AMENDMENTS TO THE DRAWINGS

REMARKS

This responds to the Office Action mailed October 12, 2007 in connection with the above identified US patent application; Applicant's counsel thanks the Examiner for the careful consideration given the application.

FIG. 32

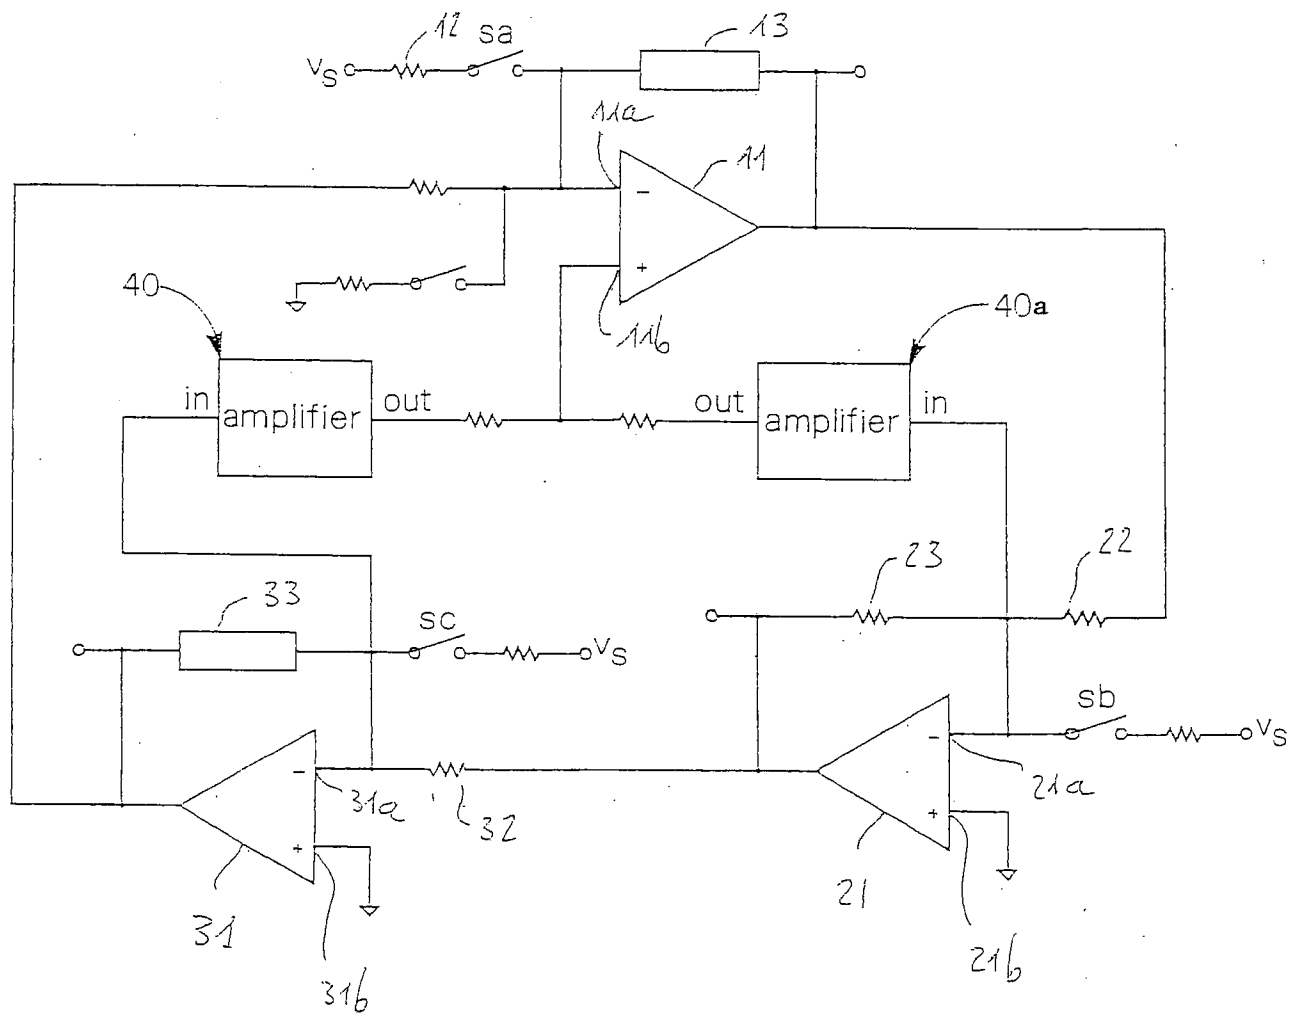
In Figure 32, reference numeral “40” in the right side of the circuit has been replaced with “40a”, in order to clarify the circuit elements shown therein.

Moreover, two different references ("fourth stage 40" and "fifth stage 40a") have been used to identify two distinct stages shown in figure 32.

Also in this case no new matter has been added, since no new elements or devices have been introduced: the amendment relates merely to the way in which the stages in figure 32 are referred to.

In Figure 32, reference numeral "40" in the right side of the circuit has been replaced with "40a", in order to clarify the circuit elements shown therein.

Applicant is attaching hereto replacement Figure 32 (marked in the top margin as “Second Replacement Sheet No. 25”), wherein such amendment has been made.

Figure 32 has been amended accordingly.

Applicant is attaching hereto replacement figure 32 (marked in the top margin as "Second Replacement Sheet No. 25"), wherein such amendment has been made.
